Addendum Number Two

Project: USC 1800 Gervais Street Renovations – Construction – Phase II
Project Number: H27-Z008-B

MECHANICAL REVISIONS

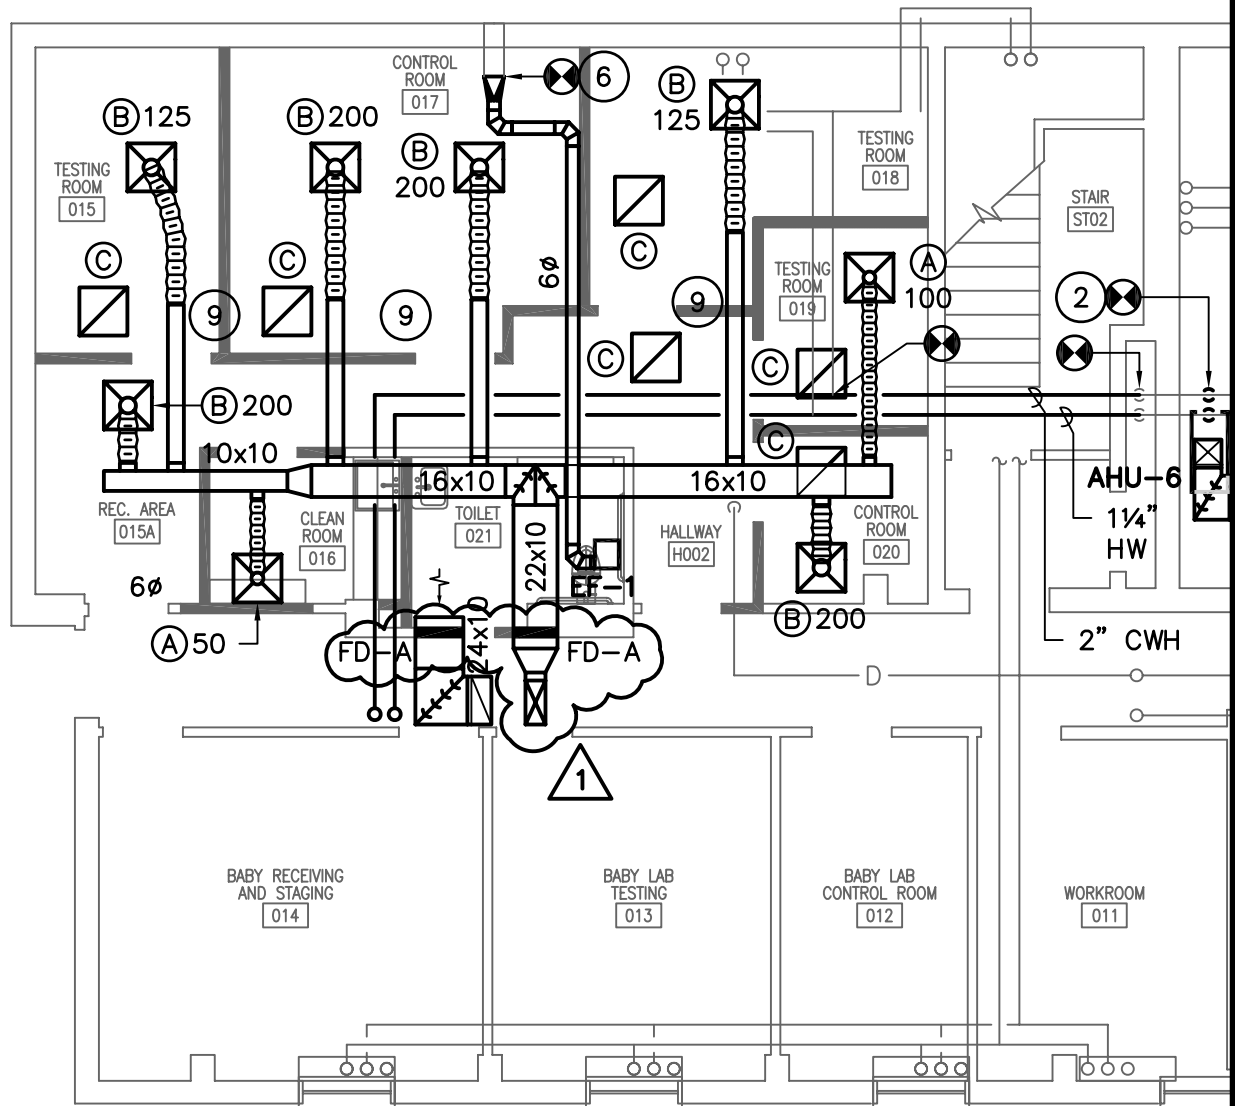
1. **SHEET M100 Floor Plans:** See attached sketch SK-M-1. This sketch adds two fire dampers to the corridor duct penetrations for AHU-5.
